ADDENDUM NO. 1

RE: The Village at Oakview
for Bristol Redevelopment and Housing Authority
BRHA-1460.00.MF.0915
T&L Project No. 12655-05

DATE: December 17, 2015

Sheet No.
ES1

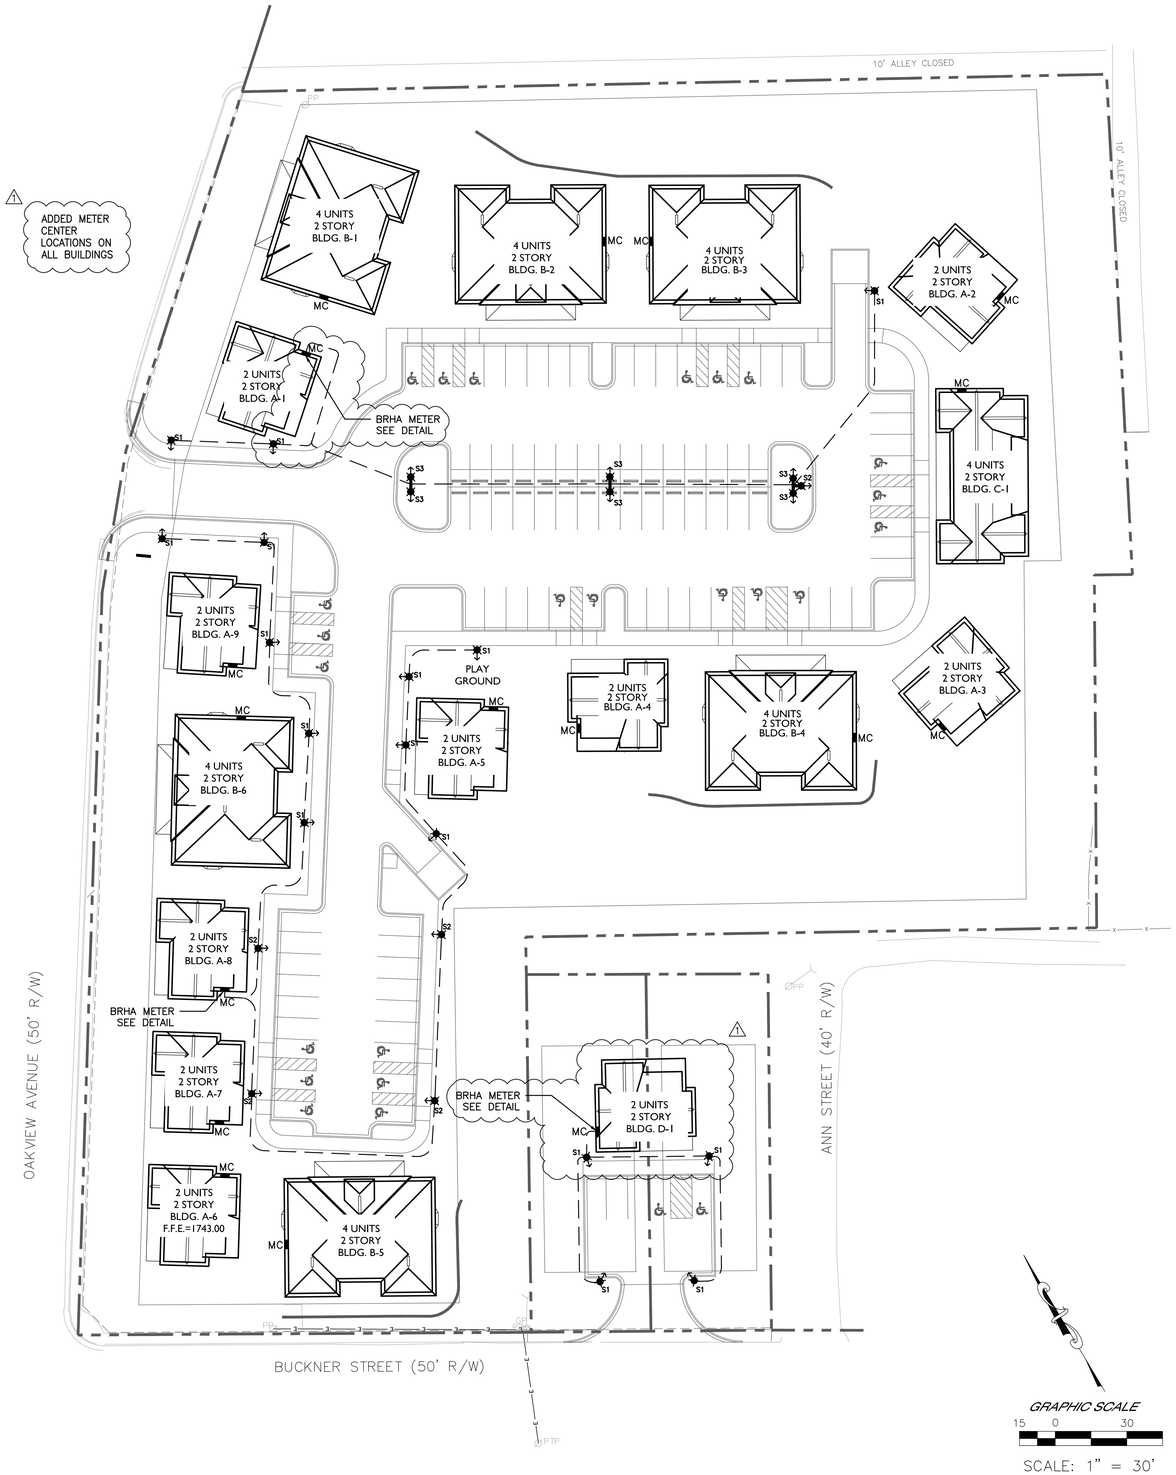
16. Refer to Sheet ES1; Outdoor Lighting Schedule; Fixtures "S2" and "S3" with pole heights of 25 feet shall be revised to 20 feet high poles. Lights grouped together shall be mounted on one pole.

17. Refer to Sheet ES1; Electrical Notes: Add Note: All site branch wiring conductors shall be #10 THWN with ground in 1" PVC conduit on 240V 2P-15A breakers.

Sheet No.
E101A

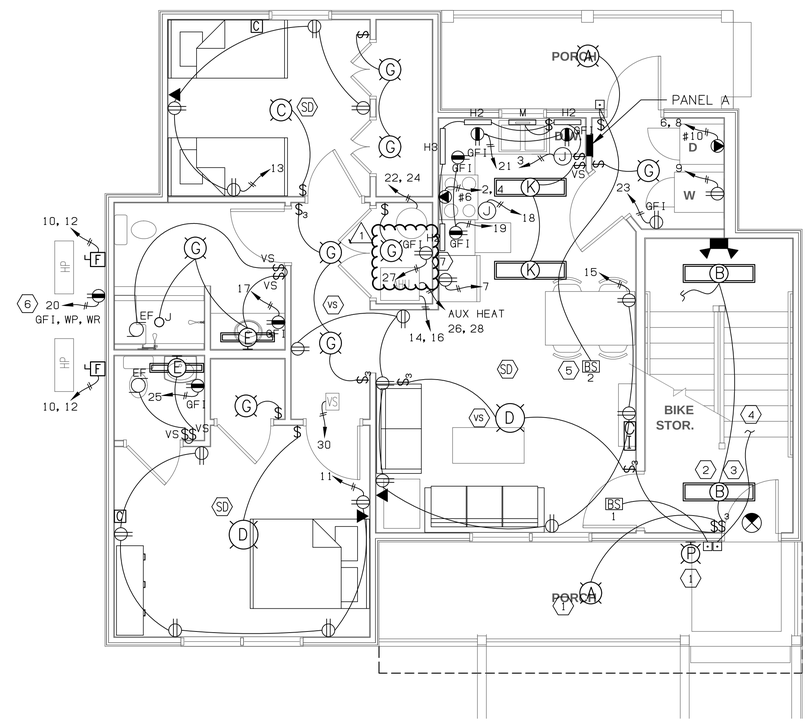
18. Refer to Sheets E101A, E102B, E103C, and E104D: Add the following GFI electrical outlets in the Mechanical Closets for future Dehumidification Units.

TRANSFORMER LOCATIONS AND RUNS

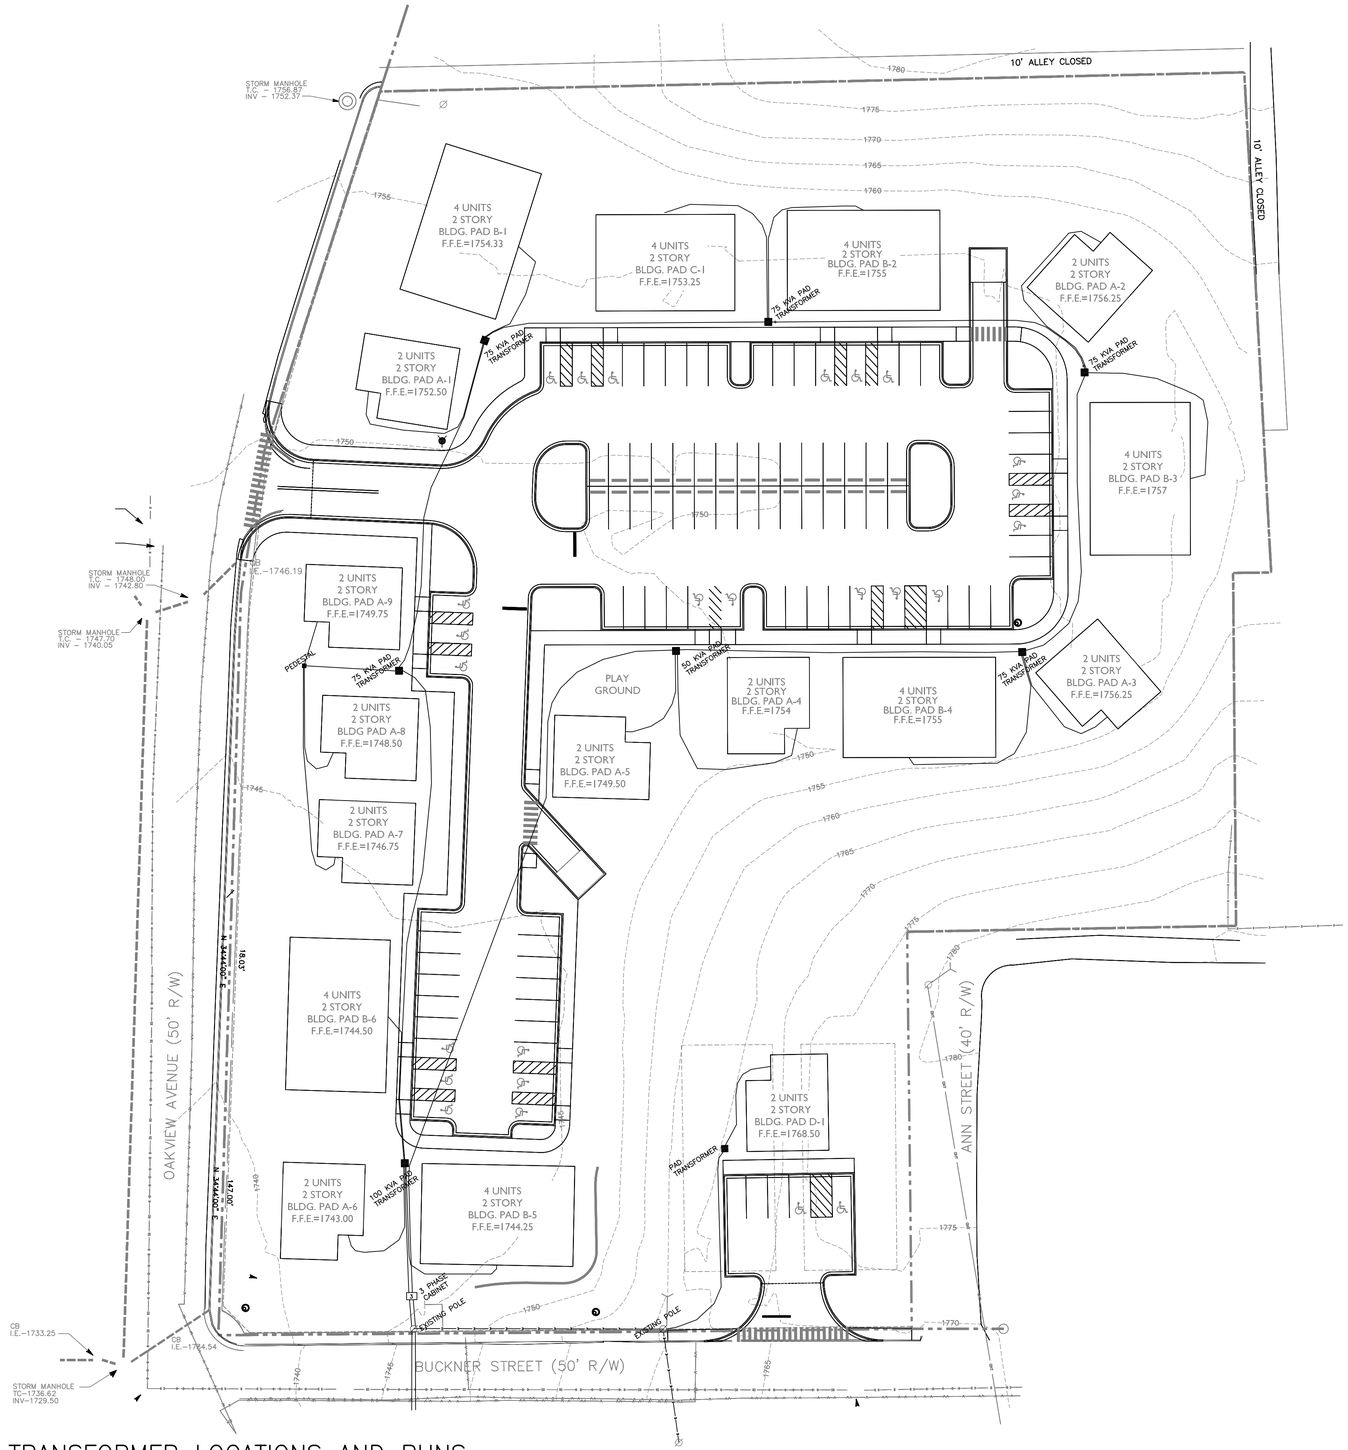
12. Site Power – Per notes, electrical service is to be installed by BVU.

a. Provide site power plan to indicate transformer pad locations and routing of secondary service to buildings.

Response: Refer to attached Drawing BVU.
